# **TOWN OF RAYMOND**

Planning Board Agenda April 20, 2023 7 p.m. - Raymond High School Media Center - 45 Harriman Hill

RE: Onyx Partners, LTD Industrial Drive, Raymond, NH JBE Project No. 21130 Application # 2022-008

On behalf of our client, Onyx Partners LTD, Jones & Beach Engineers respectfully submits an addendum letter of the Site Plan Application Book submitted to the board on January 12, 2023. These are corrections and clarifications following a thorough review of the package and comments from the board on the December 20, 2022 meeting.

Section 3, Page 30

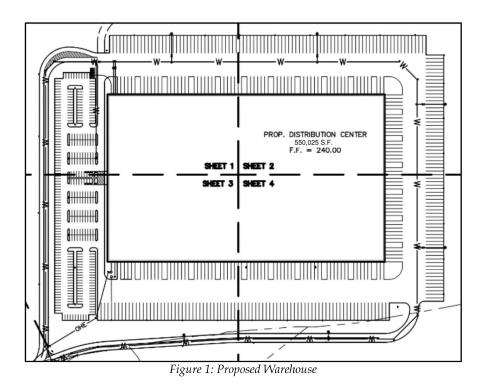
- 4. Section 3, Page 30, Code Red Consultants Memorandum: Figure 1 image shows the building area as 541,684 SF. This depicts a previous rendition of the building, however the sprinkler design conducted within the memo was done with the correct building area of 550,025 SF.

DRAWING No. **S1** SHEET 1 OF 2 JBE PROJECT NO. 21130

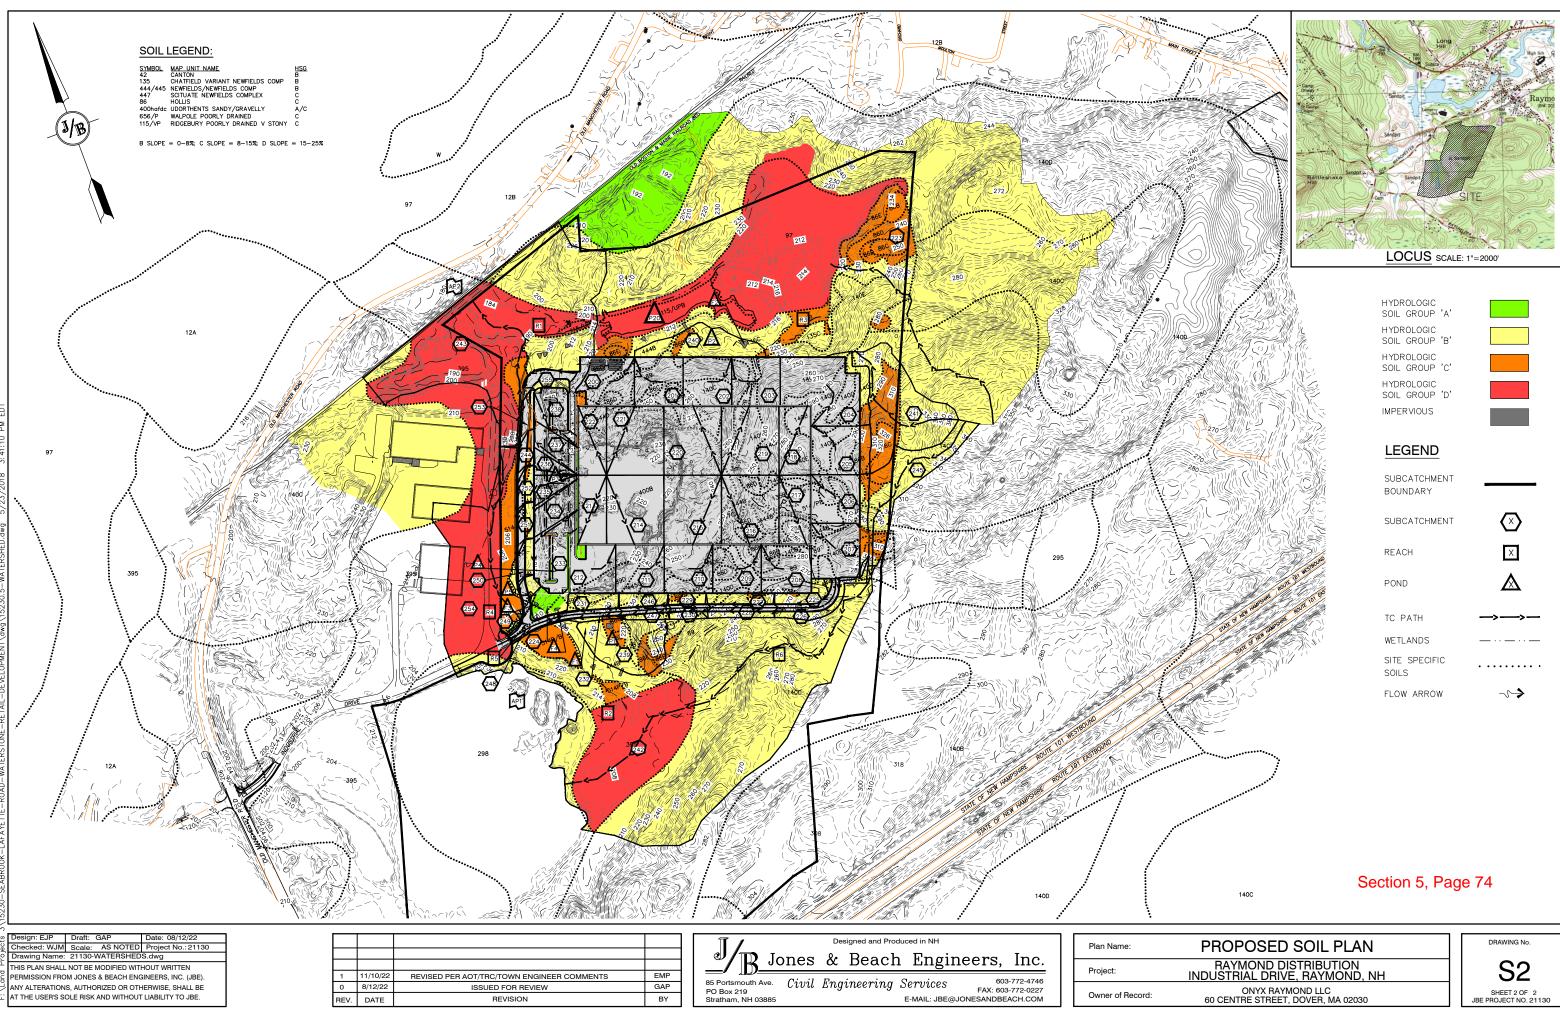
- 4. Section 5, Pages 73-74, Soil Plans S1 & S2 (11" x 17"): This plans show a incorrect Locus Map. This map has been updated and the plans included with this letter.

## Jones Brook NHDES ARCGIS MAP

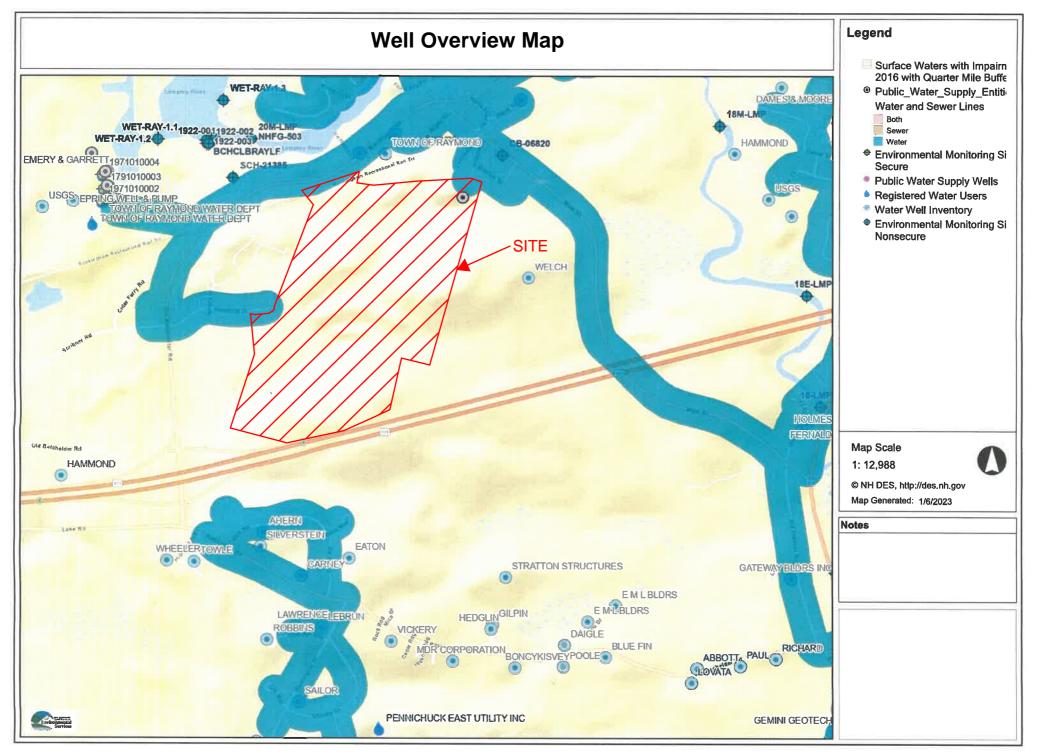
3. Section 7, Page 4, "Jones Brook NHDES ARCGIS MAP": This map has been updated to show the subject parcels to provide additional reference to our location. A copy of the map has been included with this letter.

Section 7, Page 5

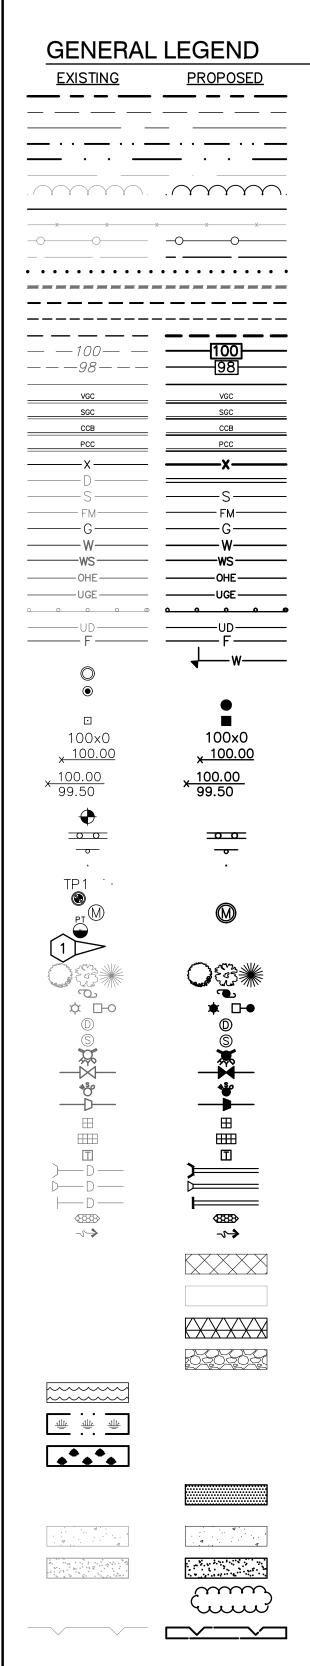
4. Section 7, Page 5, "Map By": This map has been updated to show the subject parcels to provide additional reference to our location. It has also been retitled "Well Overview Map" for additional clarification. A copy of the map has been included with this letter.

DRAWING No.
oora	Inc	Plan Name:	COVER SHEET			
eers,	lnc.	Project:	RAYMOND DISTRIBUTION INDUSTRIAL DRIVE, RAYMOND			CS

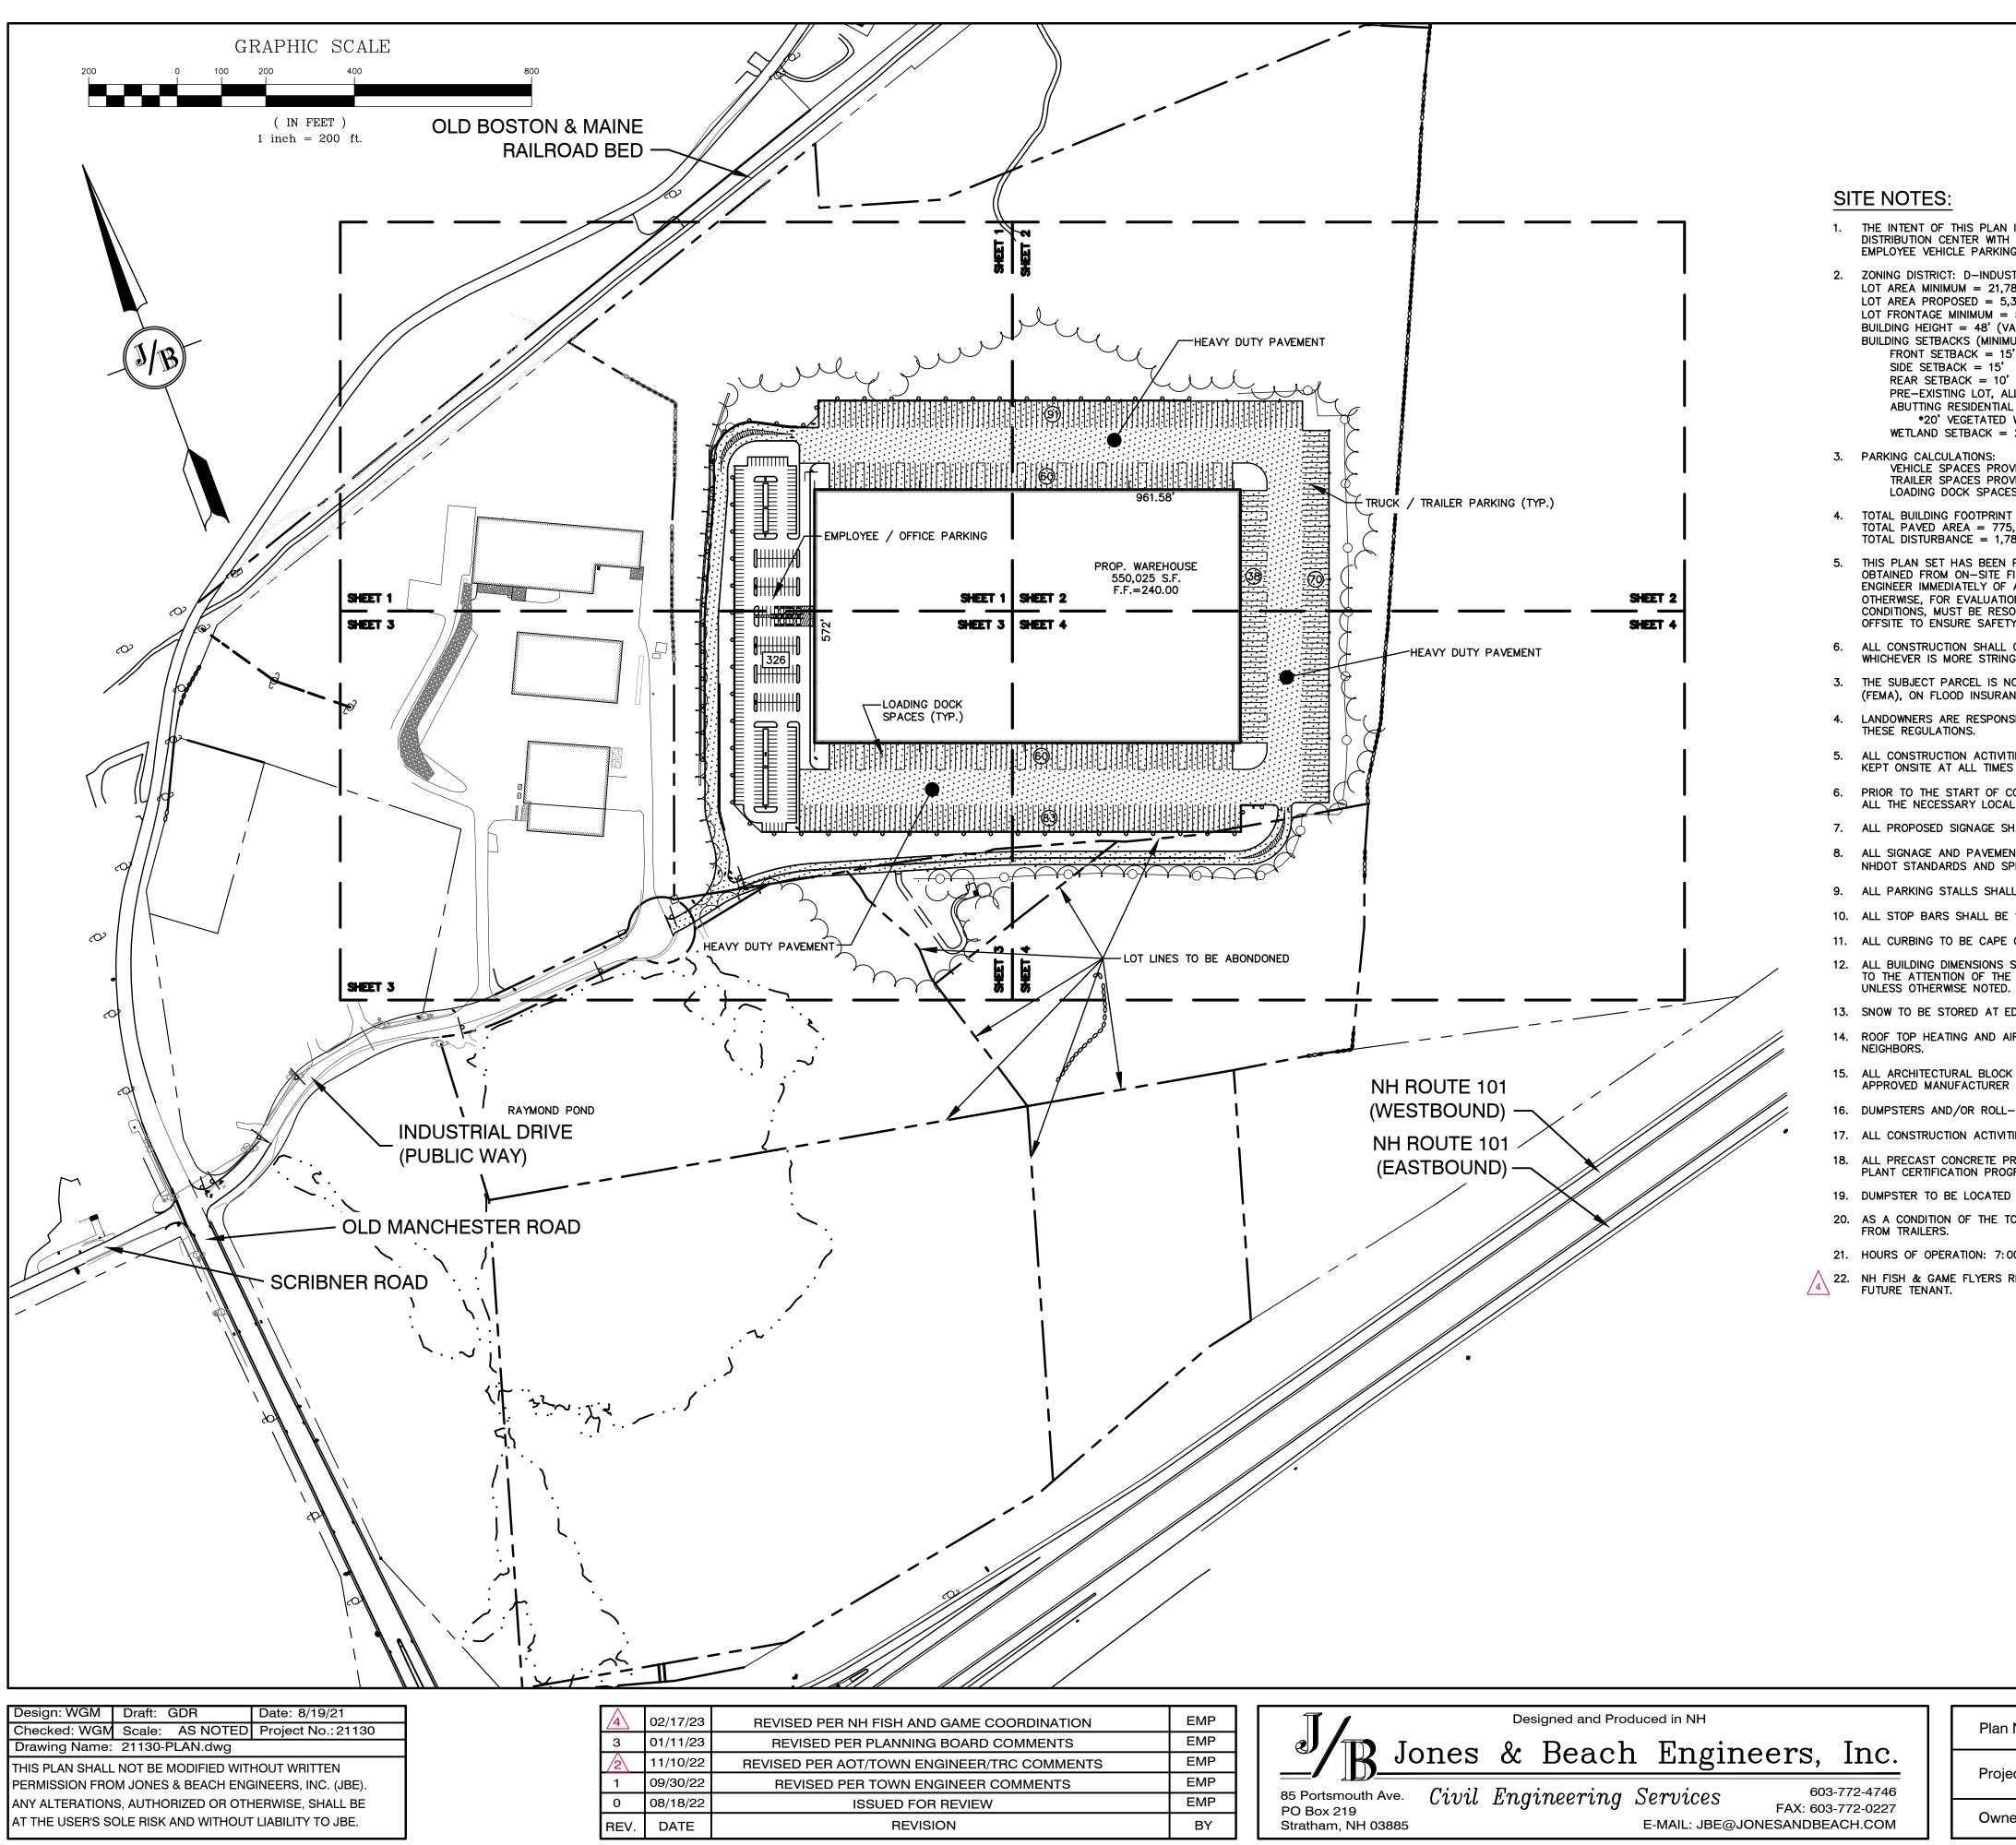
- 1. Section 8, Page 1, Cover Sheet (Sheet CS): All of the required applications that the project requires have been added to the cover sheet with their corresponding submission dates. Applications that have been approved list the date of approval.
- 2. Section 8, Page 3, Site Plan (Sheet C2): The total paved area and disturbance area listed under the Site Notes Note 4 have been reviewed and updated accordingly to match the proposed design.
- 3. Section 8, Pages 3-7, Site Plan Sheets (Sheets C2-C2-4): The total paved area and disturbance area listed under the Site Notes Note 4 has been reviewed and updated accordingly to match the proposed design.
- 4. Section 8, Page 40, Detail Sheet (Sheet D8): Filterra Tree Well details updated per coordination with Contech Engineered Solutions. This coordination resulted in minor invert changes to the discharge pipes of the tree wells.

- On the plan cover sheet, the incorrect NHB number and project description are refered in the NHF&G notes.
   RESPONSE: The plan cover sheet has been corrected to reference the correct NHB number and project description.

## FILTERRA TREE BOX: TREEWELL #1

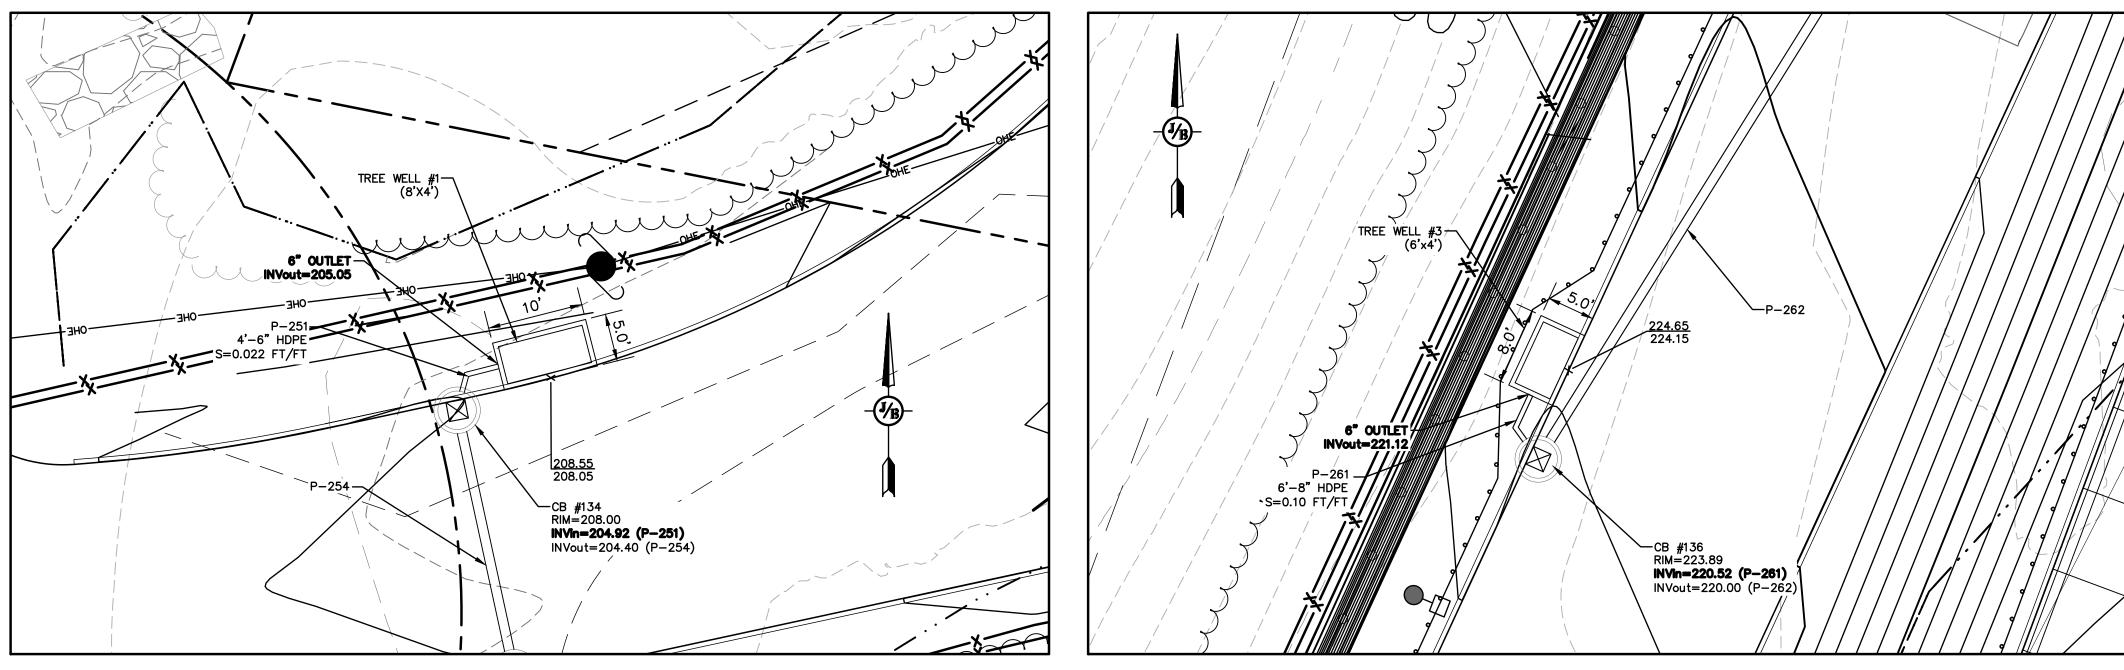
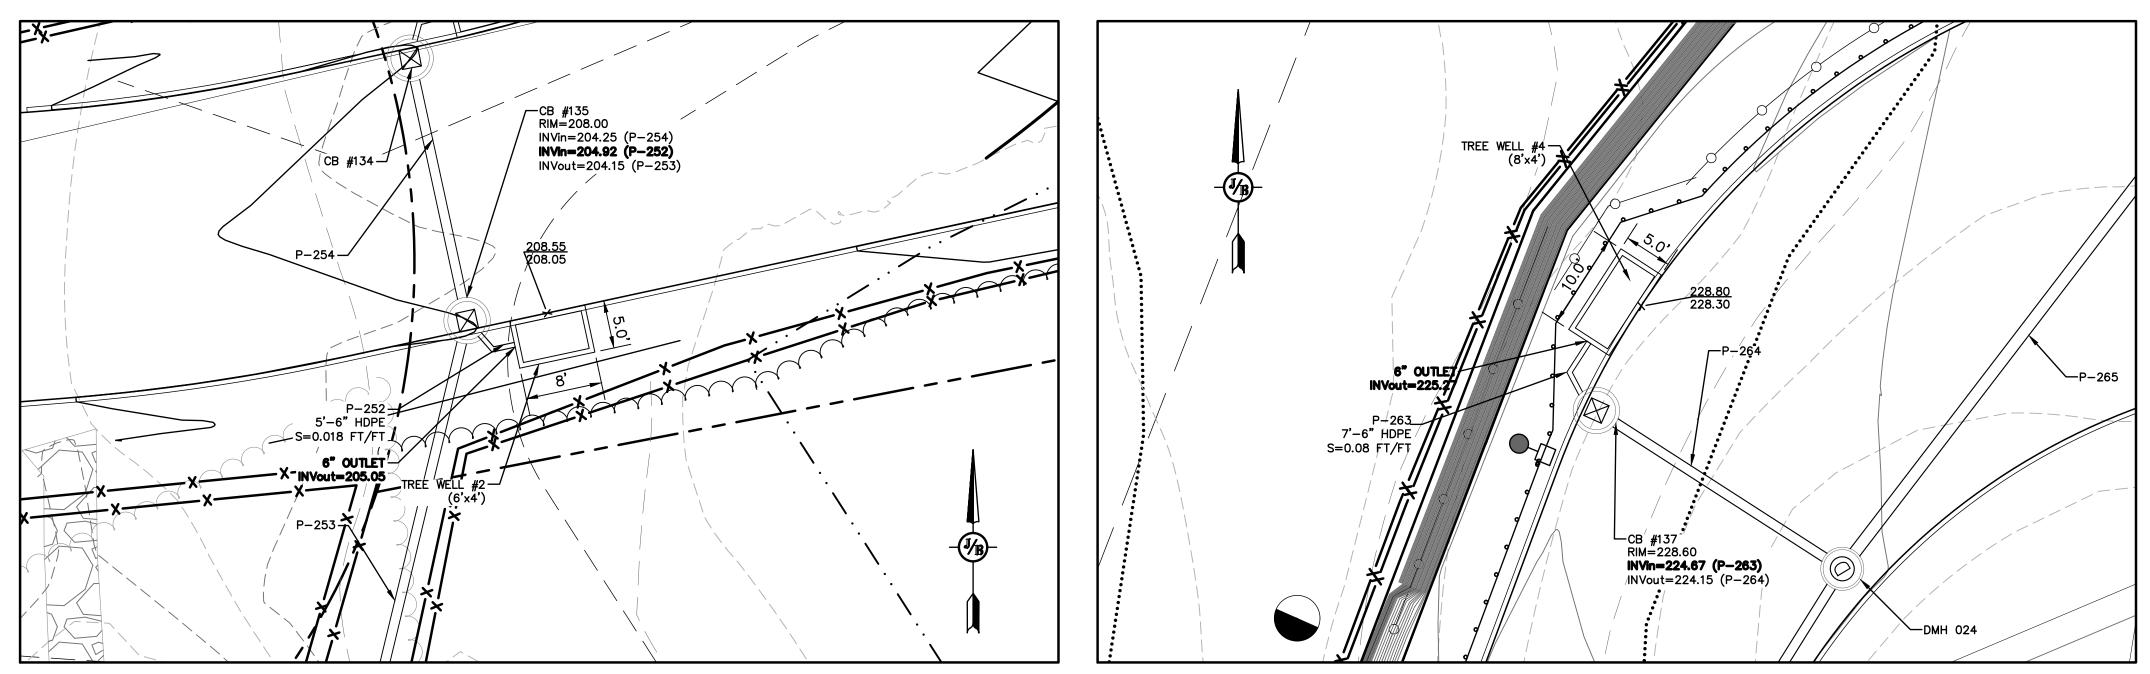
- 1. Sheet 44. Drawing No. D8. Detail Sheet.
- a. Repeat Comment: We recommend that the Applicant revise the details for the Filterra Tree Box (Treewell #1 & #2) regarding the cover rims (208.55), to be consistent with the values provided in the table (208.58) and drainage analysis (209.55). (See sheet D8).

**RESPONSE:** The invert has been adjusted to 208.55. This has been changed on Sheet D8 and the NHDES water quality sheets for Treewell's #1 & #2.
